UNITED STATES PATENT AND TRADEMARK OFFICE

APPLICATION NO.	FILING DATE	FIRST NAMED INVENTOR	ATTORNEY DOCKET NO.	CONFIRMATION NO.
10/823,650	04/14/2004	Makoto Taniguchi	119443	4916
25944 7590 01/24/2007 OLIFF & BERRIDGE, PLC P.O. BOX 19928 ALEXANDRIA, VA 22320			EXAMINER TIBBITS, PIA FLORENCE	
			ART UNIT	PAPER NUMBER
			2838	
SHORTENED STATUTORY PERIOD OF RESPONSE		MAIL DATE	DELIVERY MODE	
3 MONTHS		01/24/2007	PAPER

Office Action Summary

DETAILED ACTION

FIG. 3

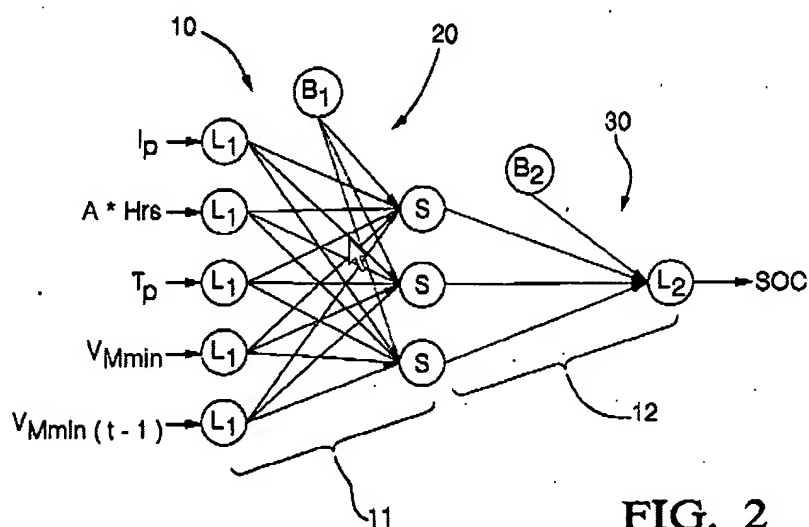
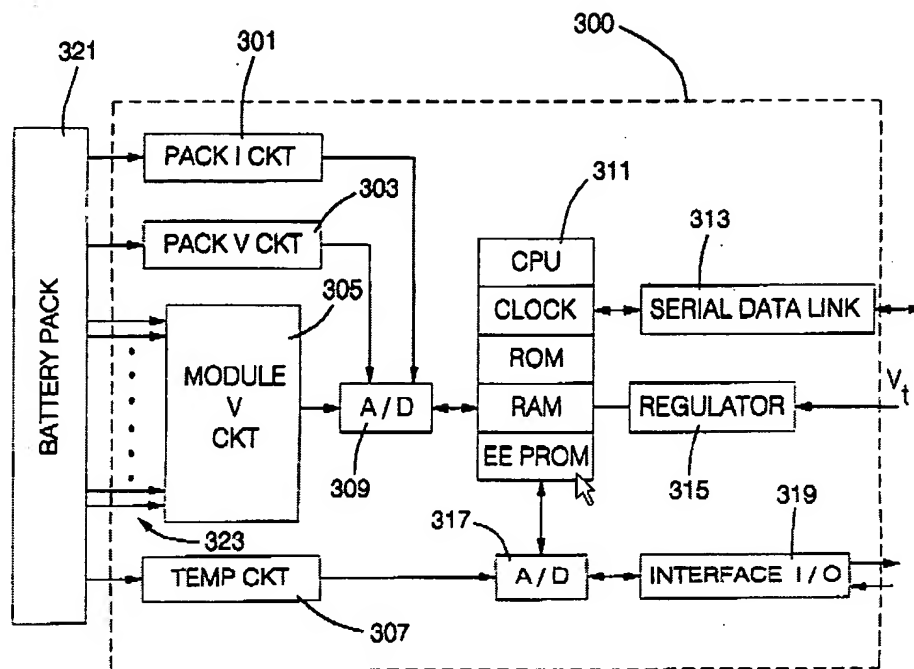
Sullivan's patent "*Method and apparatus for determining battery state-of-charge using neural network architecture*" discloses in figures 2 and 3, and at column 2, lines 1-3 and at column 4, lines 3-23:

Therefore, it would have been obvious to a person having ordinary skill in the art at the time the invention was made to modify US publication 20060181245's apparatus and allow inputs to the neural

network only during discharging, as taught by Sullivan, in order to avoid substantially non-linear relationships between terminal voltage and current of the battery.

FIG. 11A

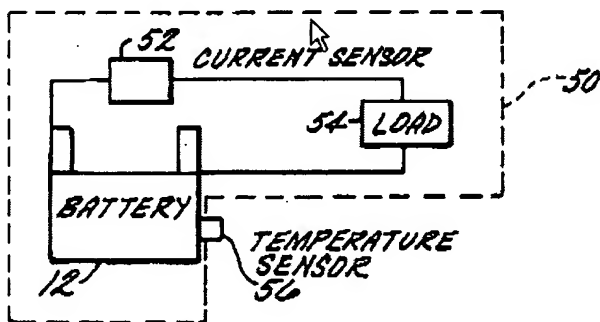
a charge accumulating device 12 for supplying power to an electric system 54 [see fig.11A];

FIG. 11B

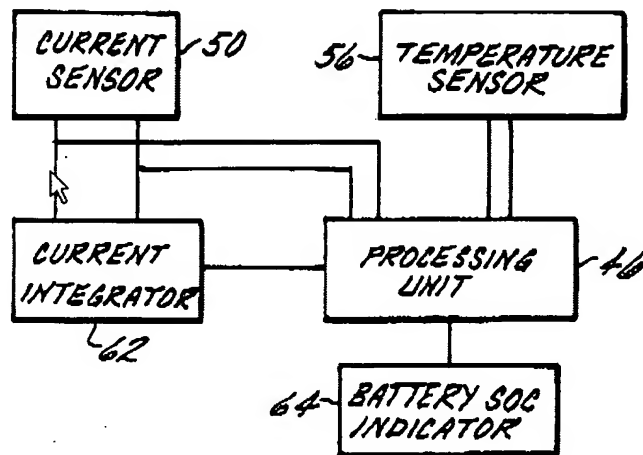
a current detecting means 50 [see fig.11B] for detecting a charging and discharging current of the charge accumulating device;

FIG. 4A

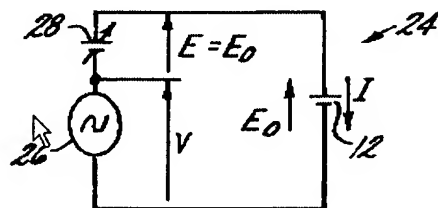
a voltage detecting means E_0 [see fig.4A] for detecting a terminal voltage of the charge accumulating device;

FIG. 1

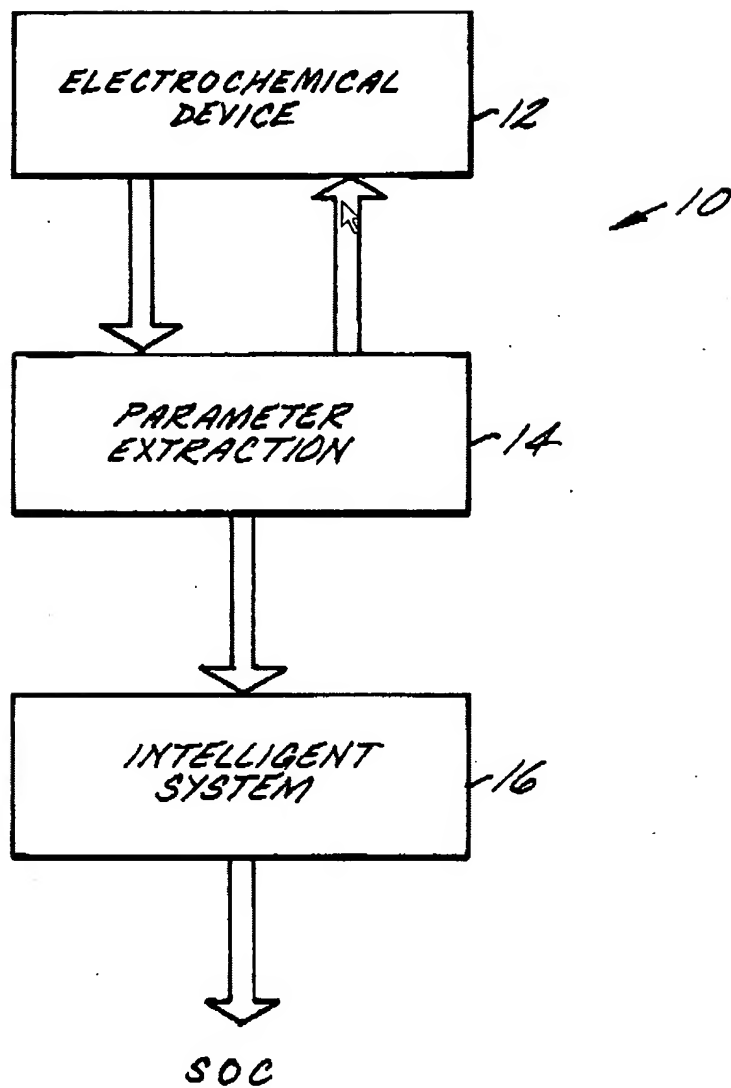
a condition detecting means for detecting an internal condition of the charge accumulating device by learning an internal condition quantity / SOC of the charge accumulating device through a neural network 16 [see fig.1] which is fed with current values and terminal voltage values output from the current detecting means and the voltage detecting means, respectively, wherein the current values and the terminal voltage values are supplied so that historical information thereof are included [see column 2, lines 63-67; column 3, lines 1-9, 48-49; column 4, lines 14-29; column 6, lines 13-14; column 8, lines 58-67; column 9, lines 1-15].

Singh does not disclose an input stopping means which, when the charge accumulating device is charged during learning, prevents the input of the current values and the terminal voltage values to the neural network until energy charged in the charge accumulating device is discharged.
